Review on 10BASE-T1S Multidrop Emission and Immunity Requirements

Sujan Pandey
NXP Semiconductors

January 23, 2018

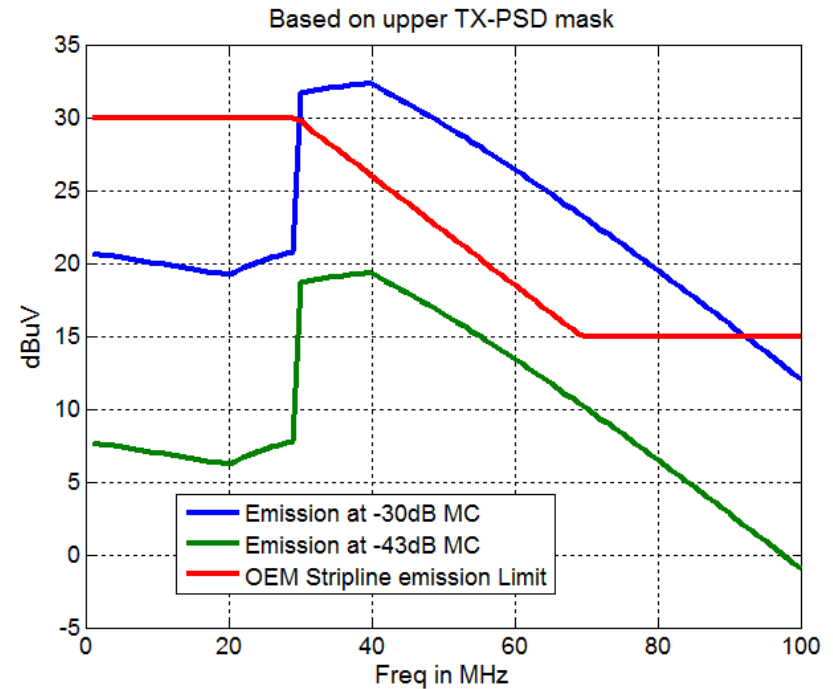
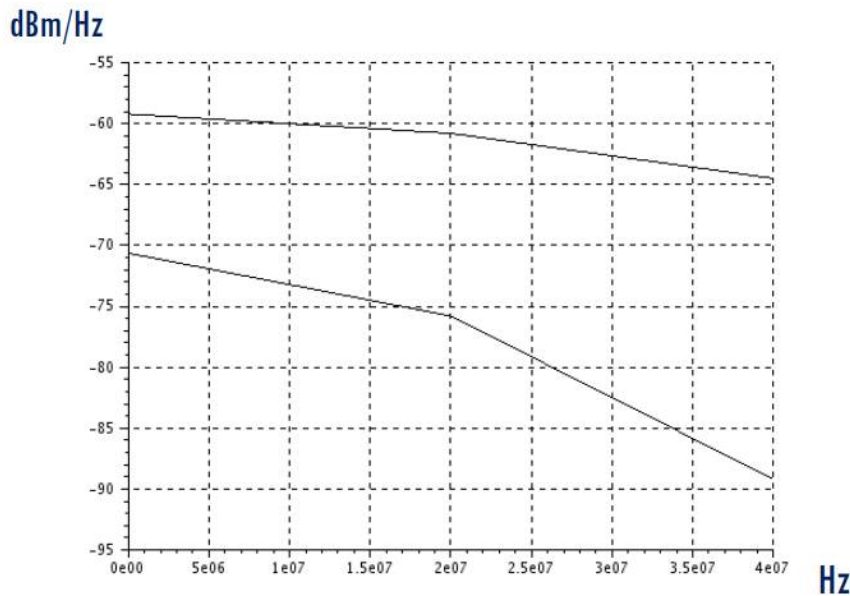
Current TX-PSD mask with -30dB mode conversion (MC) does not meet the emission requirement! Needs cable/connector with better mode conversion

- Needs better than -30dB mode conversion of channel for 10BASE-T1S to meet the automotive EMC requirements
- Agree on a common set of parameters for PHY level immunity check

25m Network with 8 Nodes

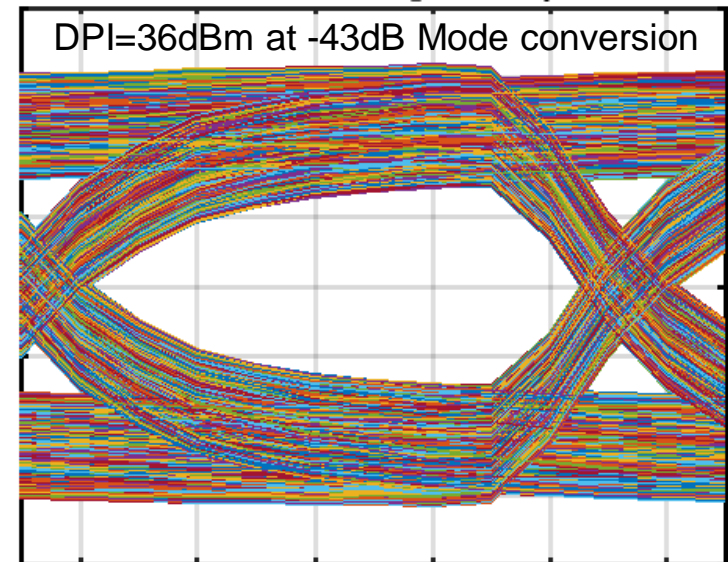
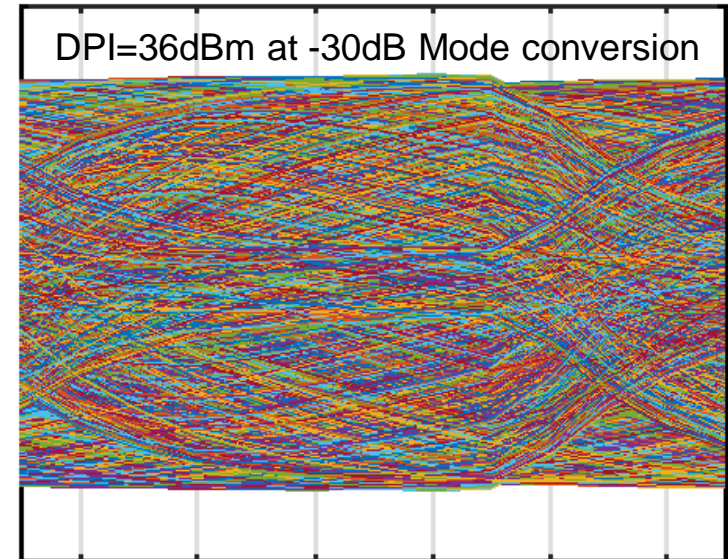
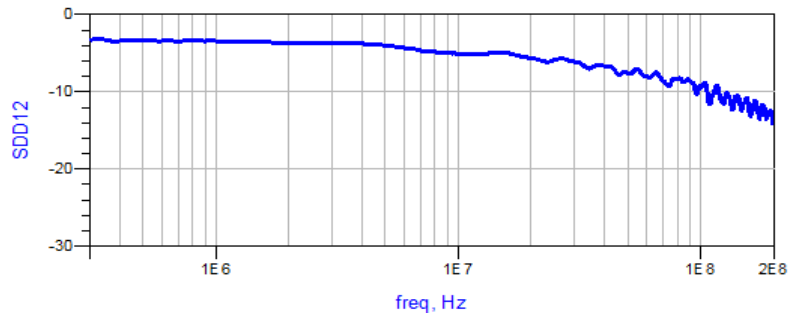
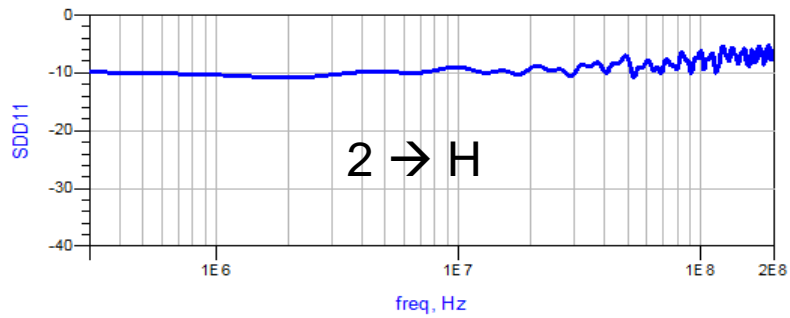
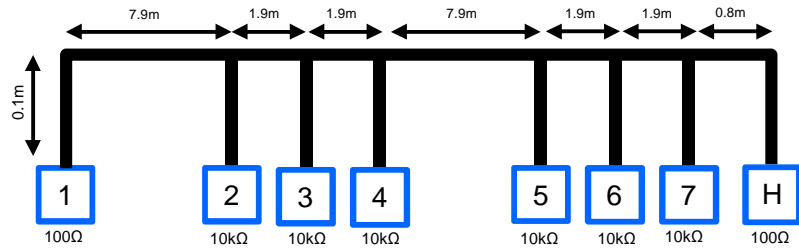
- Direct power injection (DPI) = 36dBm

- Channel with -30dB mode conversion limit violates automotive emission as well as immunity requirements
- Immunity test parameters such as BCI and impulse noises limit need to be agreed for the further simulation
- Recommendations
 - Adopt new mode conversion limit better than -30dB mode conversion
 - Need to agree on BCI limit and impulse noise for immunity limit
